Access Compliance Report

Public Rights-of-Way

(Curb Ramps)

Intersection ID: 53091	Main Street: DEERHURST_LN	Cross Street: DEERFIELD_MANOR_DR	Location: E
ADA ID: D02B6A4C06E3	Ramp Type: BlendTrans1	Initial Pass/Fail: Fail	Overall Compliance: No
Severity Score: 8.75			
Codes/Mitigation Info/Possible Solution		Field Measurements/Component Compliance

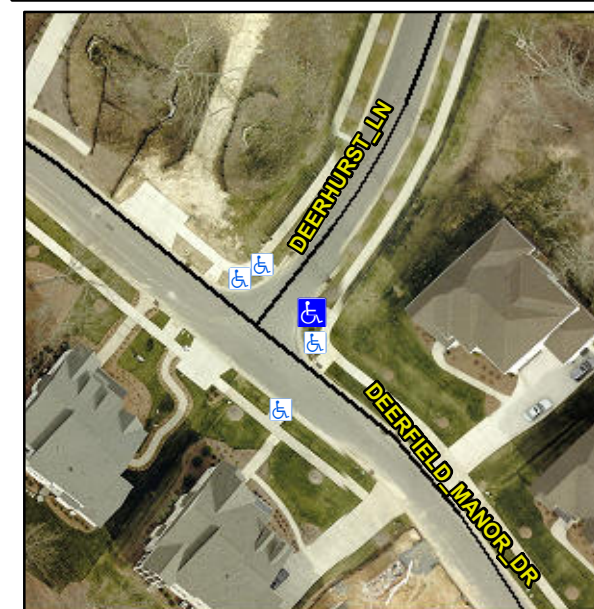
CURB LIP 1.5

R304.5.1

Compliance	Description	Data	Compliance	Description	Data
N/A	Ramp Length (in)	124.0	Yes	BlendTrans Slope (%)	1.2
No	Ramp Width (in)	47.0	Yes	BlendTrans XSlope (%)	1.1
N/A	Flare Type LT	N/A	N/A	Flare Type RT	N/A
N/A	Flare Slope LT (%)	N/A	N/A	Flare Slope RT (%)	N/A
N/A	Flare Traversable LT?	N/A	N/A	Flare Traversable RT?	N/A
N/A	Landing Length (in)	N/A	N/A	DWS Provided?	N/A
N/A	Landing Width (in)	N/A	N/A	DWS Contrast?	N/A
N/A	Landing Slope (%)	N/A	N/A	DWS Length (in)	N/A
N/A	Landing X Slope (%)	N/A	N/A	DWS Full Width?	N/A
N/A	Landing Curb? (Y/N)	N/A	N/A	DWS Offset (in)	N/A
N/A	Shared Landing?	N/A			
N/A	Gutter Ponding?	N/A	N/A	Gutter Slope (%)	N/A
N/A	Gutter Lip Ht (in)	N/A	N/A	Gutter X Slope (%)	N/A
N/A	Painted X Walk1?	No	N/A	Painted X Walk2?	N/A
	X Walk 1 Direction	To NW		X Walk 2 Direction	N/A
	X Walk 1 Width (in)	N/A		X Walk 2 Width (in)	N/A
	X Walk 1 Slope (%)	3.9		X Walk 2 Slope (%)	N/A
	X Walk 1 X Slope (%)	0.5		X Walk 2 X Slope (%)	N/A

Remove & Replace Curb Ramp With Two New Directional Ramps or Equivalent.
